TITLE D3000 OPERATOR CONTROL PANEL SWITCHES				PIB NO. DK3031
PRODUCT LINE	TAPE DISK FORMATTER <input checked="" type="checkbox"/>	EQUIPMENT CHANGED Switch 102357-XX	MODEL SERIES AFFECTED D3000	EFFECTIVE DATE 4/15/75

TITLE D3000 OPERATOR CONTROL PANEL SWITCHES

PIB NO.
DK3031

COMPU-LITE SWITCH WIRING

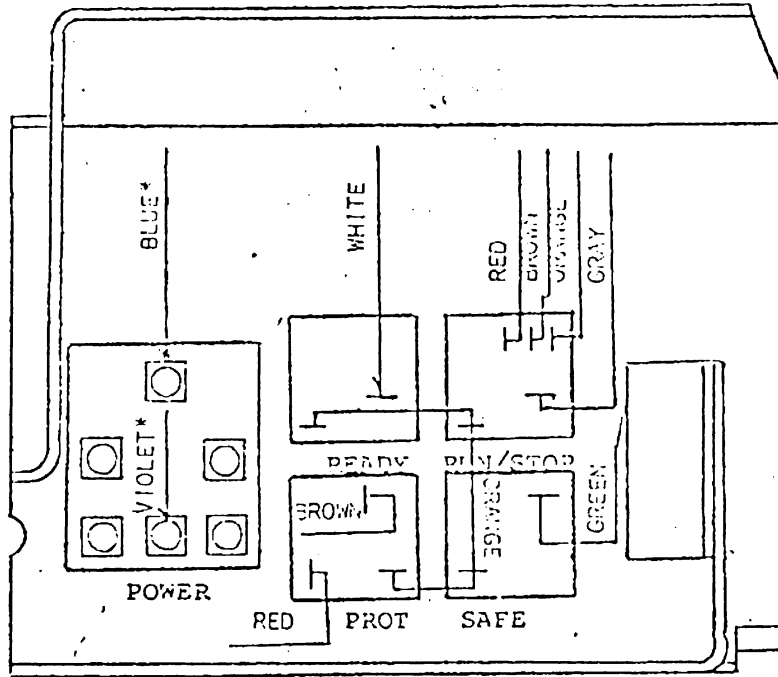
PURPOSE: Current production D3000 operator control panel assemblies are being equipped with Licon brand switches instead of Compulites. Operationally these two switches are identical. There are however, some integral differences which are outlined below.

- Although the switch assemblies are interchangeable, the switch caps, between Licon and Compulite, are not. i.e., READY, SAFE, PROT/PROT and RUN/STOP. Should a cap replacement on a Compulite switch become necessary a complete Licon switch with cap should be ordered. Licon numbers are as follows:

- When replacing a switch in the operator control panel, refer to appropriate figure for wiring. (Attached)
- Ensure that before installing the switch that the switch terminals are twisted 45°. If the 45° twist does not exist, the terminal could be pushed into the switch body causing damage inside the switch.
